STAFF REPORT
(Final Plat, Preliminary Plat Approved 2/18/99)

CASE NUMBER: S/D 99-10 - SCHOLFIELD-HATCHETT 4TH ADDITION

LOCATION: North side of Kellogg, East of Greenwich Road

VICINITY MAP

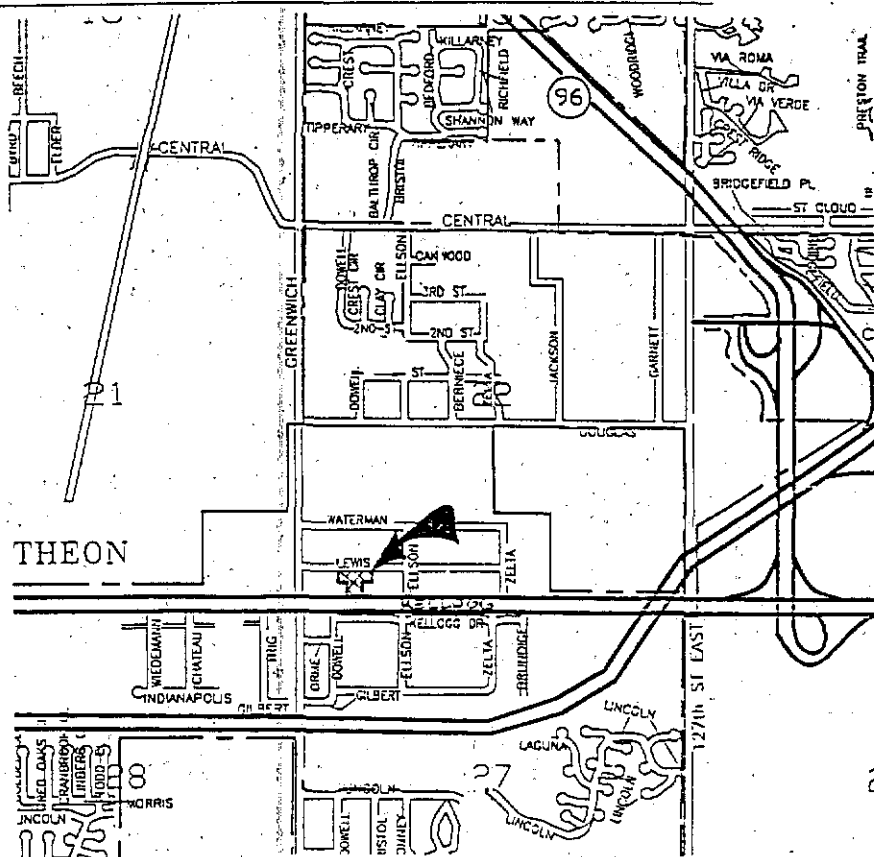
- A. Existing municipal services are available to serve this site. City Engineering needs to verify if any other additional easements or guarantees are required. The 10-ft east-west sanitary sewer easement shall be increased to 20 feet.

The final plat tracing shall denote this easement.

- B. If improvements are guaranteed by petition, a notarized certificate listing the petitions shall be submitted to the Planning department for recording.
- C. City Engineering needs to comment on the status of the applicant's drainage concept. The drainage concept is approved. On-site detention will be required at the final plat stage.
- D. The zone change approval prohibits access from Lewis Street as long as the properties north of Lewis remain zoned residential. The final plat shall indicate complete access control along Lewis on the face of the plat and reference the access controls in the plat's text.

- E. The zone change approval required the applicant to participate in the paving of Lewis Street. A petition for the paving of Lewis shall be submitted.

- F. The applicant is reminded that in accordance with the Protective Overlay, a 10-foot landscape buffer and fence is required along the north line of the plat along with a landscaped street yard in accordance with the City Landscape Ordinance.

Complete access control along Lewis has been denoted on the final plat.
